**WINDOW REPLACEMENT, RE-CLADDING AND  
ASSOCIATED WORK**

**STRATA PLAN LMS 280 – CHATEAU COMOX  
1272 COMOX STREET, VANCOUVER, B.C.**

**SPRATT EMANUEL ENGINEERING LTD.  
PROJECT No. S08-273  
February 21, 2008**

DES. M.W.E.	SCALE 1/4"=1"
DR. MMc	S08-273-5
DATE 2/25/08	SHEET 5
	A

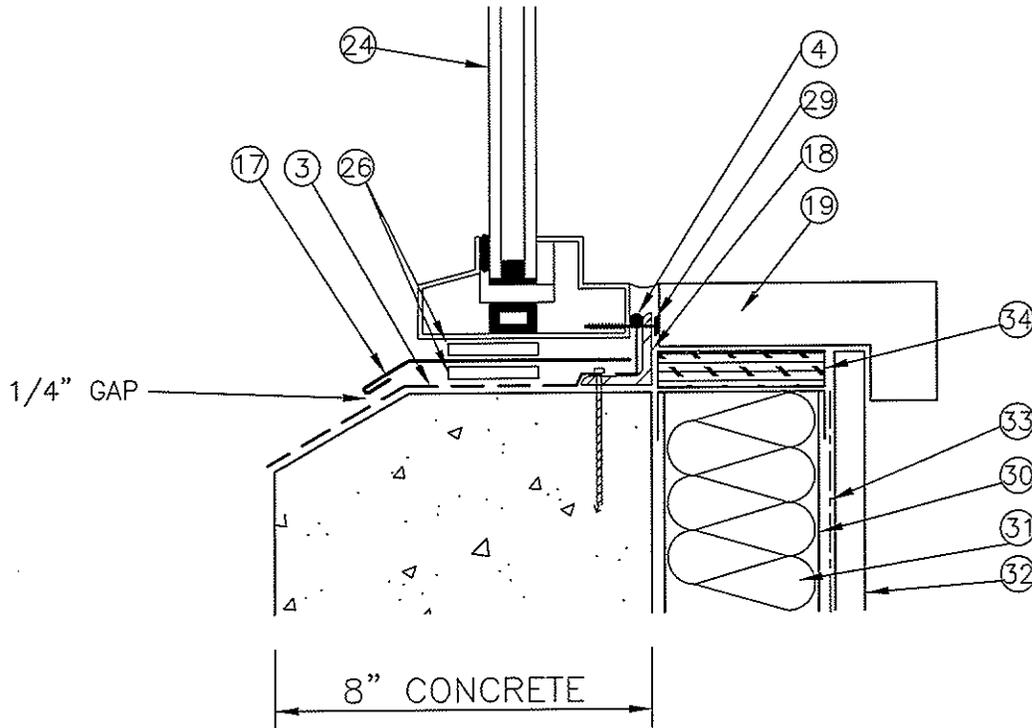
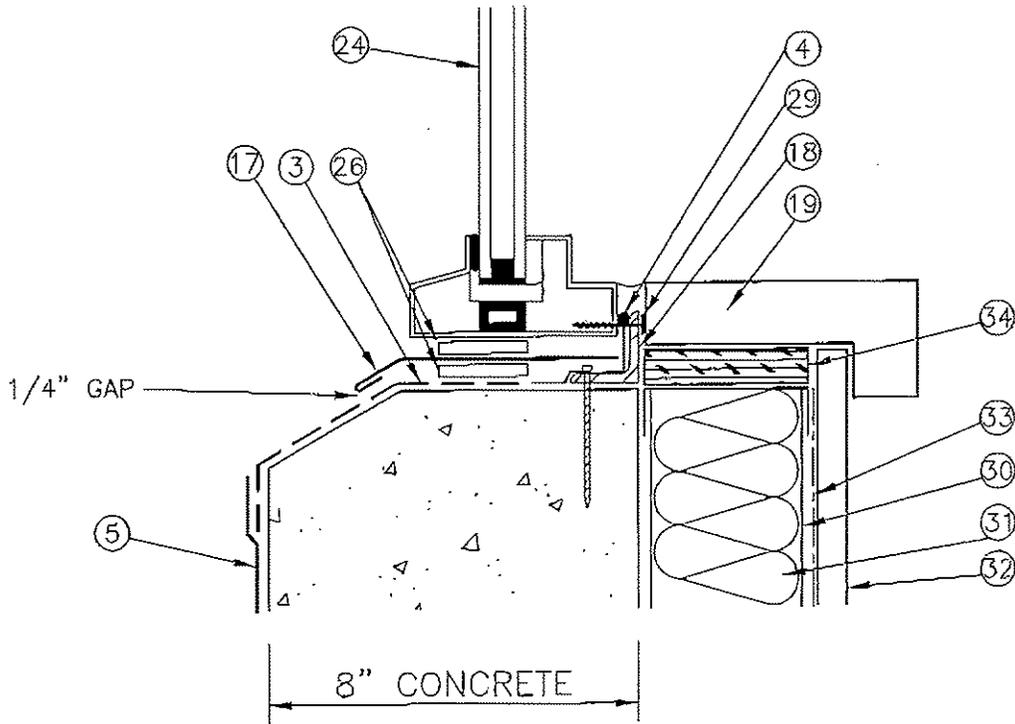
Delete the sentence "Note that the window sills on the curved portion of the building shall be detailed with Urelastic 5000-6000 polyurethane traffic membrane by Universal Polymers Ltd.". This sentence shall be changed to "Note that the window sills on the curved portion of the building shall be detailed with Parapro 123 Flashing System by Siplast as per Revised Detail S08-273-5 and 15.". This product is quick drying and will allow same-day reinstallation of windows and doors.

Details S08-273-5, S08-273-7, S08-273-15 and S08-273-17 have been revised.

DES. M.W.E.	SCALE 1/2"=1"
DR. MMc	S08-273-7
DATE 2/25/08	SHEET 7
	A

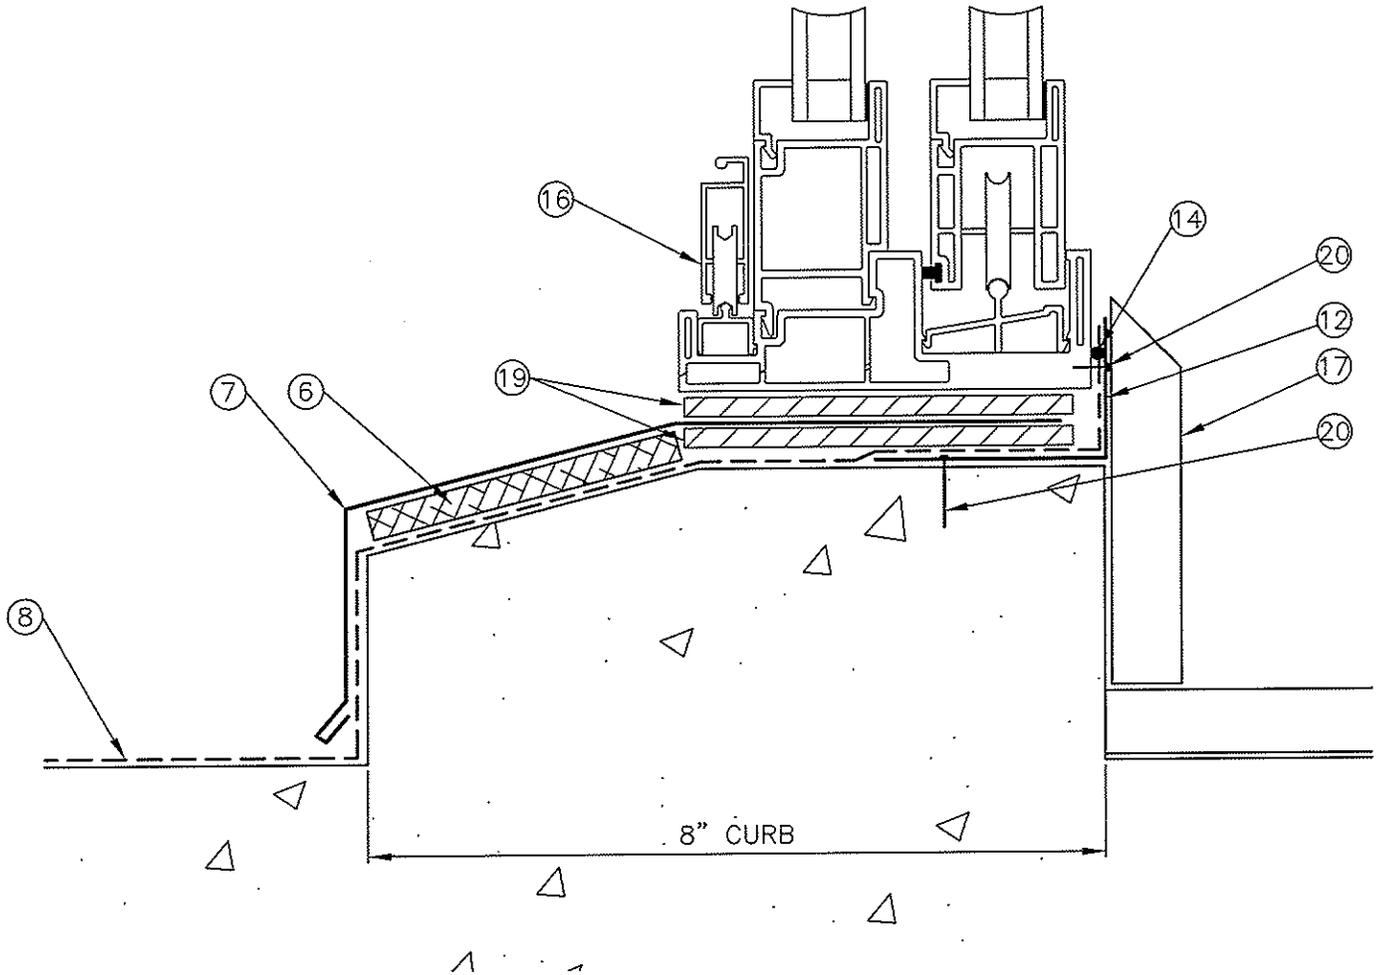
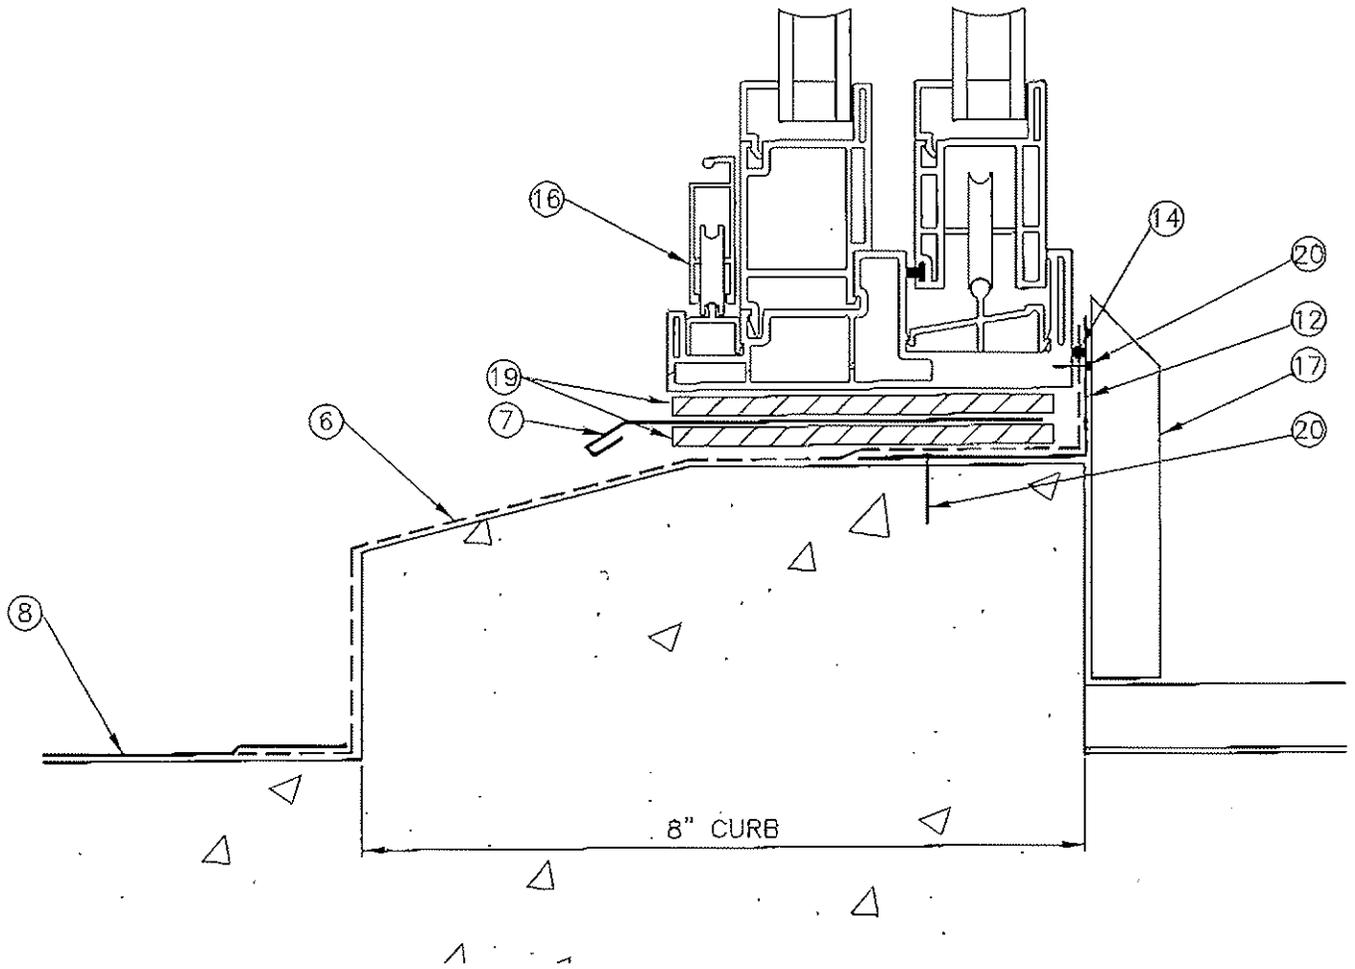
Delete the sentence "Also, the membrane shall be used to detail the door sills of both the new and reinstalled sliding door/window units." This paragraph shall be changed to "The rough opening of the door sills of both the new and reinstalled sliding door/window units shall be pre-stripped using Parapro 123 Flashing System by Siplast, as per Revised Detail S08-273-7".
